December 13, 2011

**Subject: Engineering Review of Water Quality and Drainage Issues Associated with the Proposed Casey Development**

**Figure 1. Total Suspended Solids Pollution Increases from the Proposed Casey Development**

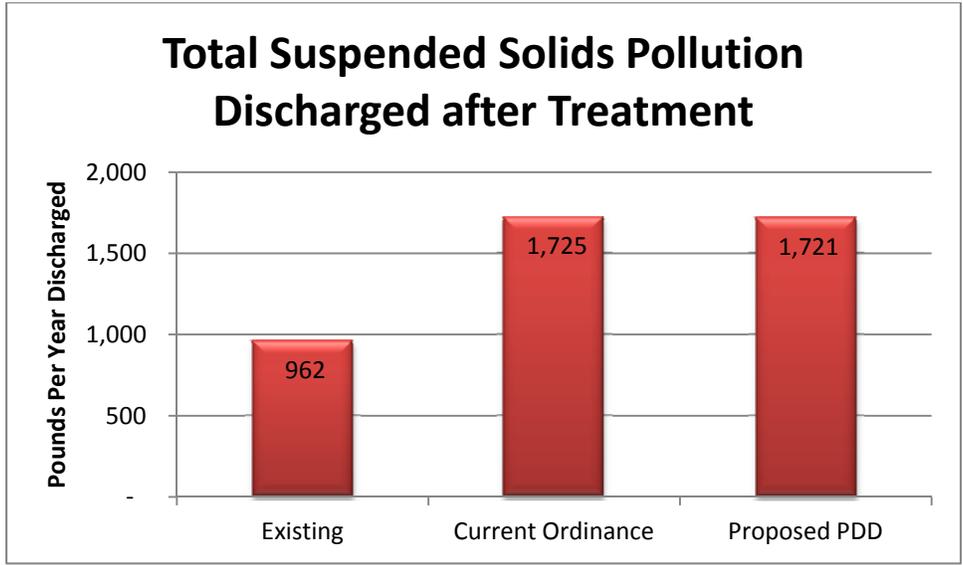
The City of San Marcos Land Development Code §5.2.4.1 requires development with more than 15 percent impervious cover to implement best management practices to limit total suspended solids increases from development to no more than 20% above that which would occur from natural drainage from the site. The proposed Planned Development District agreement states that the project will achieve a minimum of 85% total suspended solids removal.

Figure 1 illustrates differences in average annual total suspended solids from the site as it is currently constructed, from a code-compliant development, and from the proposed Planned Development District project. The increase in total suspended solids above that of the current development is 758 pounds per year, which is 80% of the current average annual loads.

**Figure 2. Chemical Oxygen Demand Pollution Increases from the Proposed Casey Development**

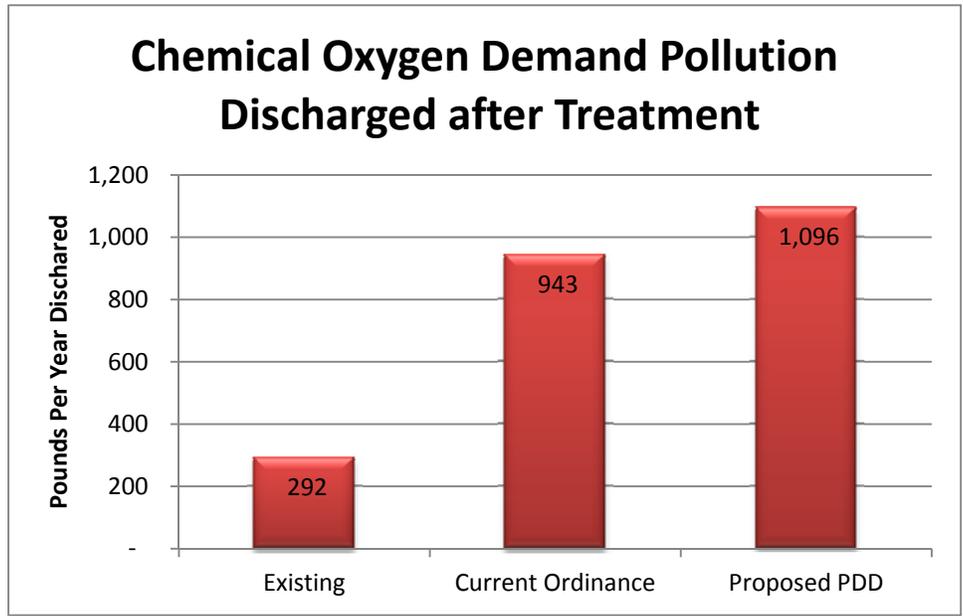
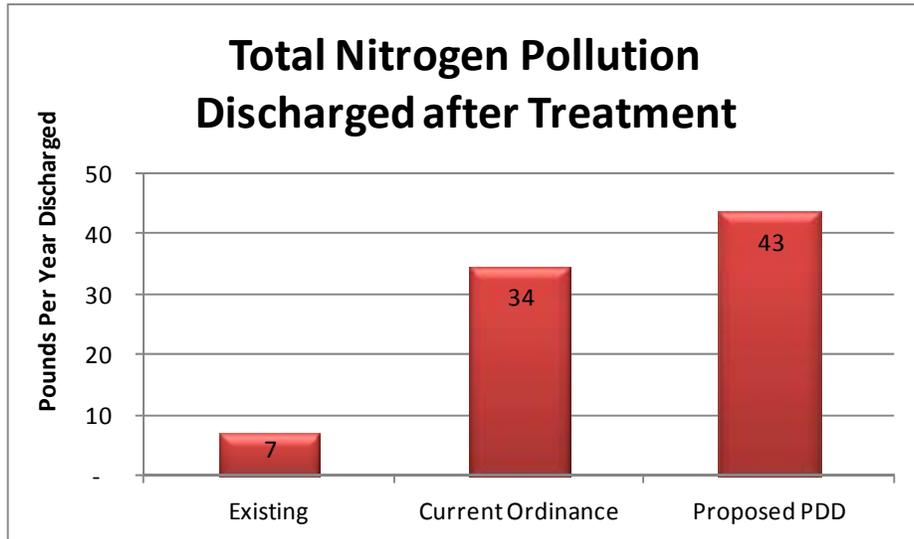
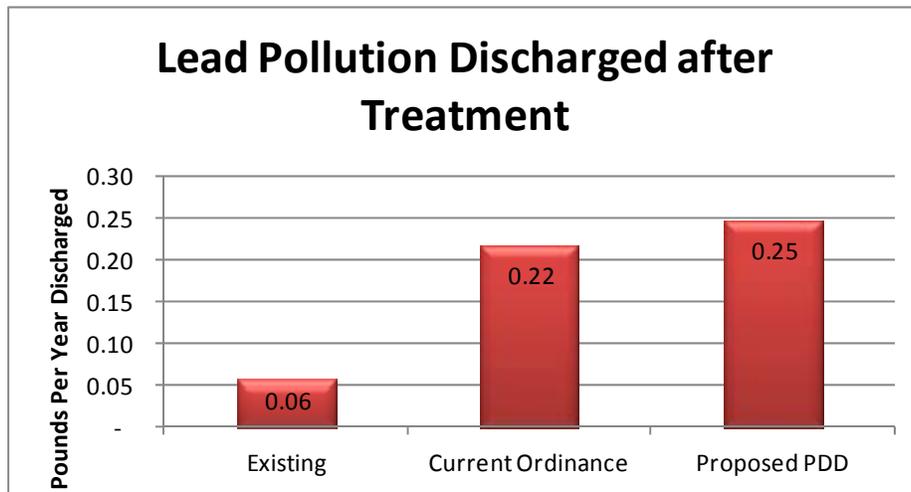
Runoff treatment to remove total suspended solids does not, however, ensure removal of other pollutants present in storm water including nutrients, toxic metals, and organic chemicals like gasoline and motor oil components. These chemicals are commonly found in storm runoff from parking areas and garages. They are more degrading of the quality of the stream than suspended sediment alone.

The proposed Planned Development District would allow increases in nitrogen, lead, and chemical oxygen demand pollution compared to discharges from development under the current zoning, as shown in Figures 2 through 4.

**Figure 5. Storm Runoff Volume Increases from the proposed Casey Development**

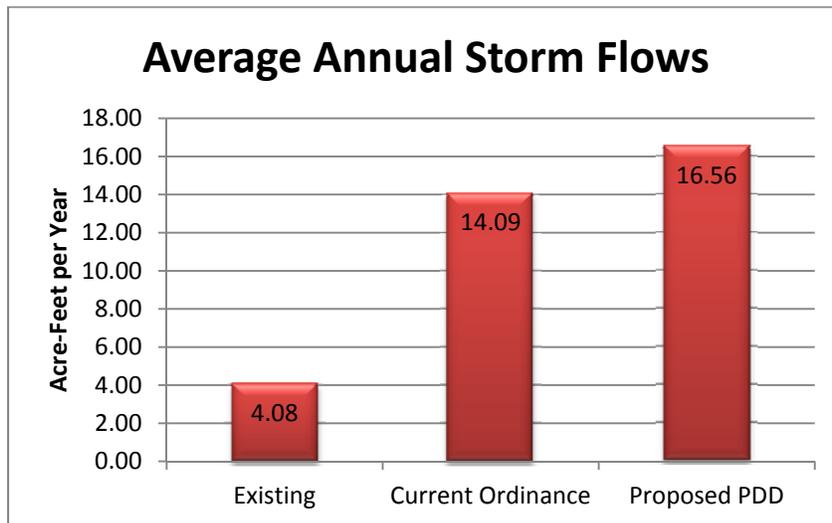
In addition to increasing pollution, the additional impervious area that would be allowed by the proposed development will increase the total volume of storm runoff from the site. As shown on Figure 5, the average annual volume of storm runoff would increase by a factor of slightly more than three compared to the current conditions.

The consequences of this increase in storm runoff volume would be only partly mitigated by flood detention to limit peak storm flows to pre-developed rates. Even with no increase in the peak flow rate, the duration of the peak flow must be extended to discharge the extra runoff volume. The consequences of the extended peak flow duration will be longer flood periods and higher flood elevations when the extended peak flow overlaps with peak flow rates from downstream contributing areas.

**Figure 6. Channel Enlargement with Increasing Impervious Area**

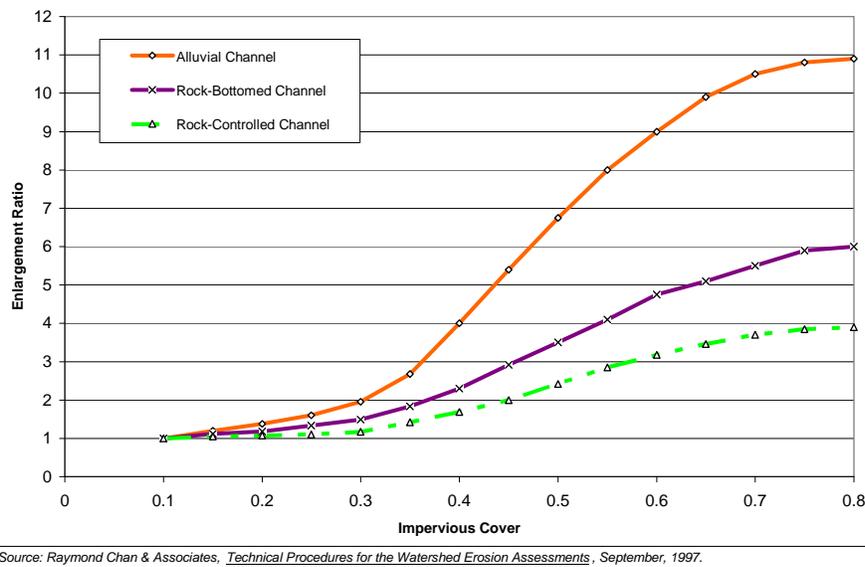
Downstream channels will also adjust to the increased volume of storm flow by deepening the channel bottom to bedrock, and widening the channel cross-section. Bank erosion and the loss of trees, fences, outbuildings, and sometimes structures will occur during the channel adjustment period. A rock-bottomed channel cross-section conveying flows from an area developed with 60% imperviousness will be almost five times larger than the cross-section of a channel conveying flows from an area with 10% imperviousness.<sup>7</sup> See Figure 6. The contribution of bank and channel bed erosion from this channel cross section readjustment to stream sediment loads will overshadow any total suspended solids reduction from the proposed Best Management Practices to reduce total suspended solids in the site discharge.
